NORTHERN BEACHES LOCAL PLANNING PANEL

WEDNESDAY 5 APRIL 2023

ITEM 4.1	DA2022/1650 - 8 BAROONA ROAD, CHURCH POINT - ALTERATIONS AND ADDITIONS TO A DWELLING HOUSE INCLUDING A SWIMMING POOL.
AUTHORISING MANAGER	Adam Richardson
TRIM FILE REF	2023/181592
ATTACHMENTS	1 ↓ Assessment Report 2 ↓ Site Plan & Elevations

DEVELOPMENT APPLICATION ASSESSMENT REPORT

Figure 4 : Extent of non-compliance with the side building envelope at the northern elevation (shown in green cross-hatch)

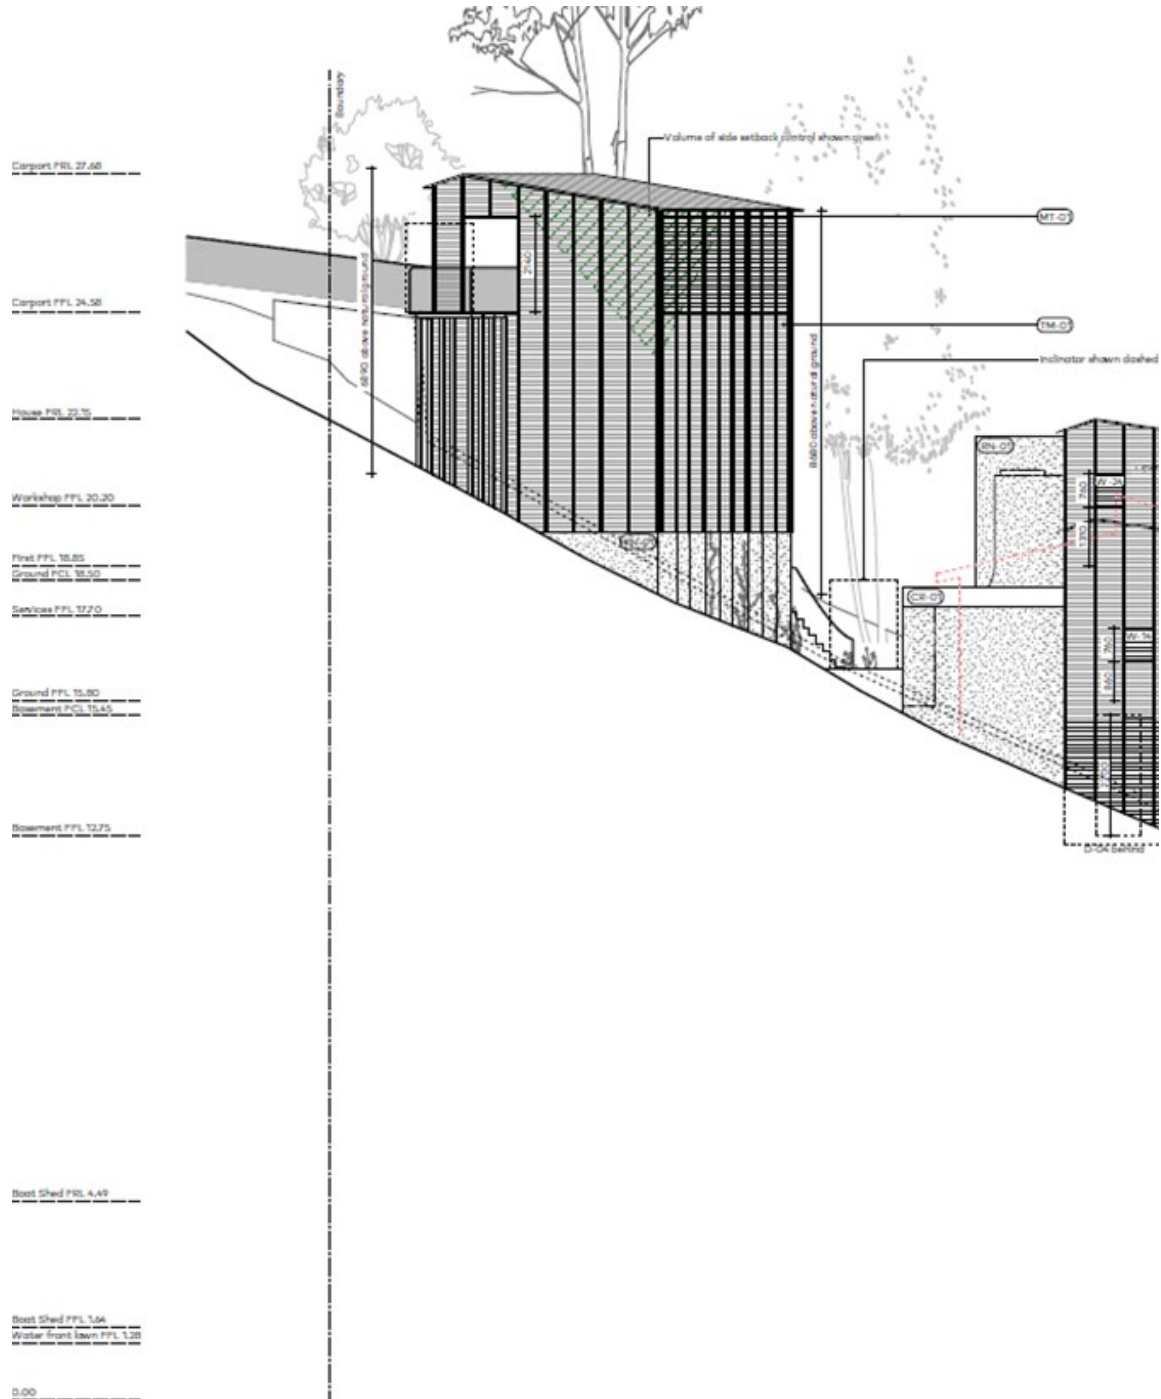
As the slope of the building envelope for the dwelling and garage both exceed 30%, the following merit assessment was undertaken.
